Replacement Notes for : Image 1000

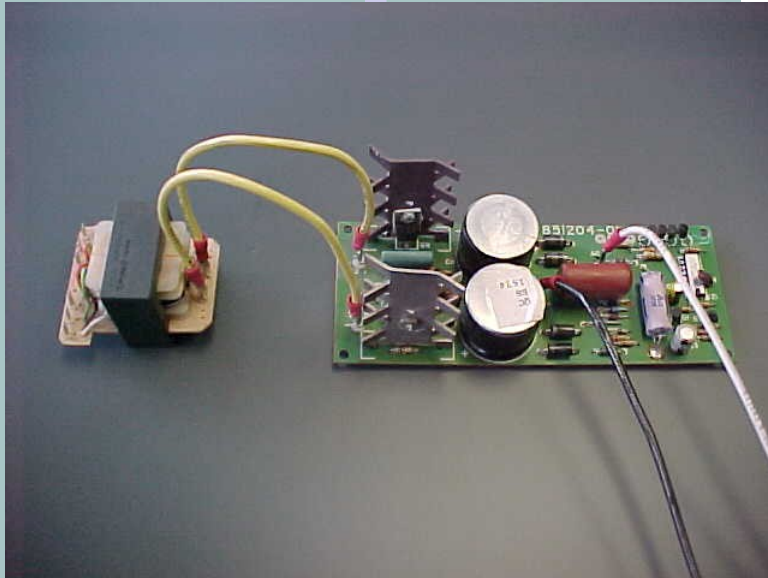
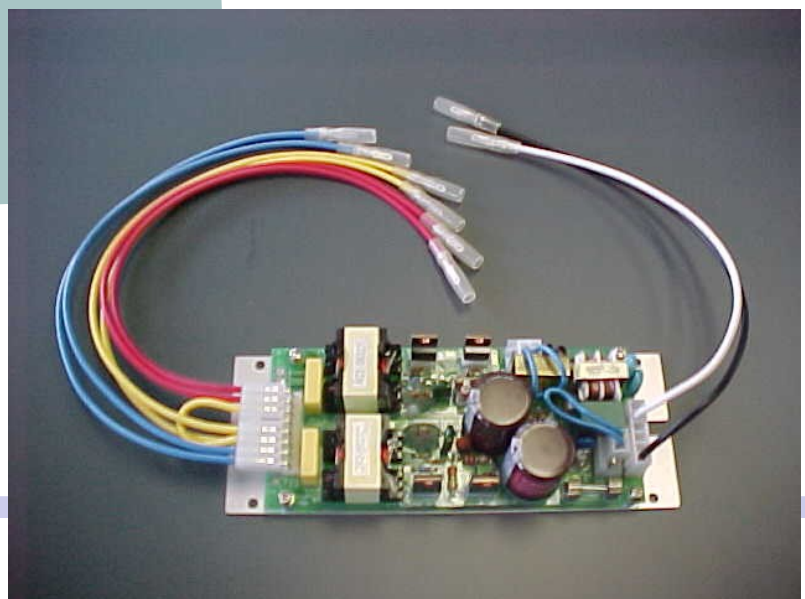
Image 1000 ballast with transformer, pictured at left, is replaced by the FA100 ballast using adapter harnesses 2-6IN-220-TA for the input and 7-8OUT-TA for the output, as pictured below. The old external transformer is no longer needed. Move both input voltage selectors on the FA100 to 220-volt mode.
